8. Atkinson Subdivision Savely Addition; KPB File 2024-095 Fineline Surveys / Savely Location: Crooked Creek Road

ITEM #8 - PRELIMINARY PLAT ATKINSON SUBDIVISION SAVELY ADDITION

KPB File No.	2024-095
Plat Committee Meeting:	October 14, 2024
Applicant / Owner:	Marty Savely Jr & Susan Savely
Surveyor:	Dmitri Kimbrell / Fineline Surveys
General Location:	Crooked Creek Road, Kasilof Area

KPB 2024-095

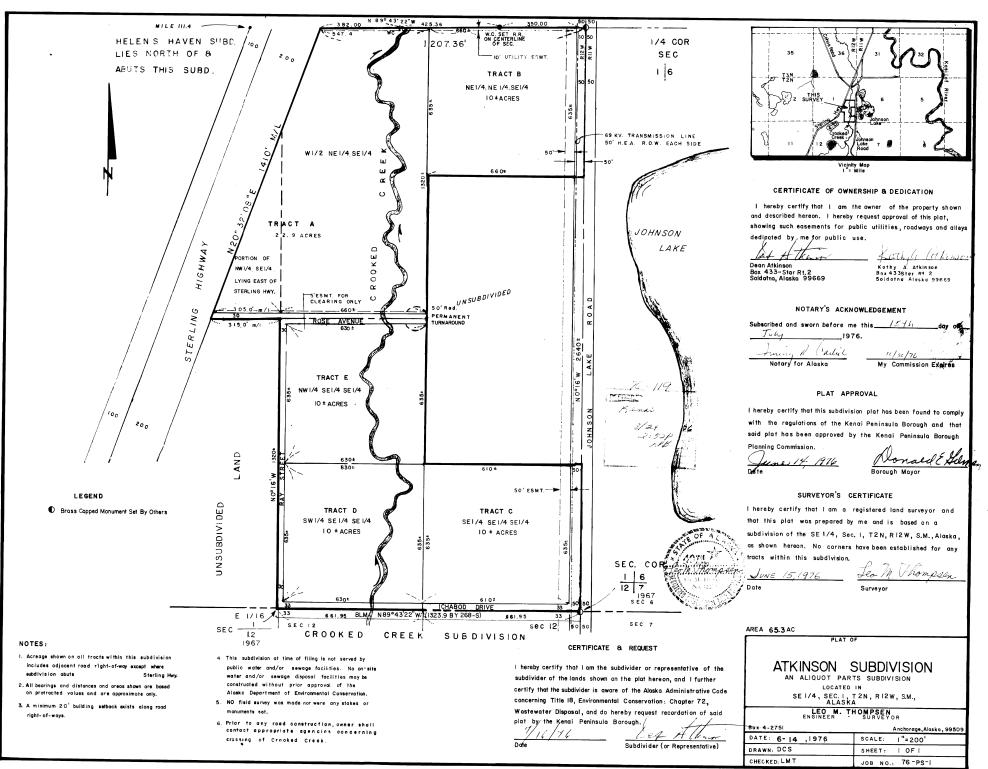
The subdivision is not affected by a section line easement. However, there are section line easements running north-south on the east side of the plat. **Staff recommends** that the surveyor verify the size of the section line easement and indicate it on the drawing.

There are steep areas on the plat, indicated by a line for slopes greater than 20%. **Staff recommends** that the surveyor show both the top and toe of the slopes to better identify them, as the current line only indicates the top and does not define the slope.

There are easements shown on the parent plat that need to be caried forward and shown on the current platting action. **Staff recommends** that the surveyor carry include all easements from previous plats concerning this lot.

HEA provided comments requesting the surveyor to depict and label the approximate location of the two overhead electric lines and add plat notes that carry forward the easement from plat KN 88-50. The comment will be included in the staff packet.

- Add the 20-foot building setback as per KN 76-119 to the drawing and include an appropriate plat note.
- Modify plat note #2 to change "of adjoining right-of-way" to "of building setback."
- Identify the BLM caps as their corner identities in the system.
- Move the S1/16th corner south along the line to be more consistent with the detail.
- Add the date of October 14, 2024, to the Plat Approval.

Modify the plat label in the legal description as follows: KN 88-50

Show the opposite side of the ROW for definition.

CTP indicates a section line easement, verify and show

Add name of lake to the east of plat.

Label the center of the two easements from the parent plat Add the 10' easement on the north line from the parent plat

Include a note for the wetlands on the plat

Increase text size of label

Possible encroachments on the sidelines of the plat. If any encroachments are found during field work, please identify them on the final plat and submit a solution addressing these encroachments.
